SERVICE INFORMATION BULLETIN

APPLICABILITY: 2017-18MY Crosstrek w/ CVT

SUBJECT: New Select Lever Component Parts Information

NUMBER: 16-116-18

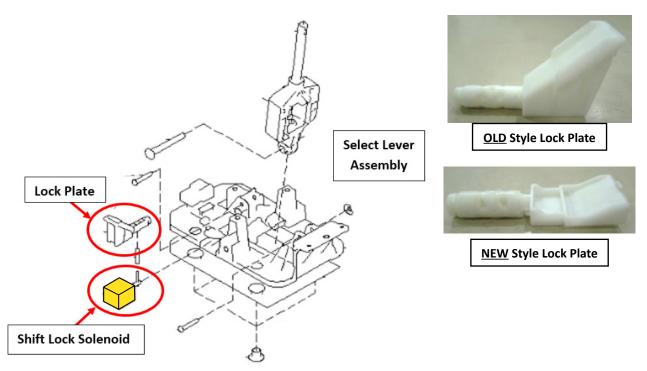
This Service Information bulletin provides details about revised CVT select lever (shifter) components. The shape of the lock plate and output of the shift lock solenoid have been changed.

The **NEW** shift lock solenoid case is **YELLOW**. (The original part had a blue case.)

Description	Part Number
SOLENOID UNIT-SHIFT LOCK, RH	35173FL000
LOCK PLATE COMPLETE	35142FL000
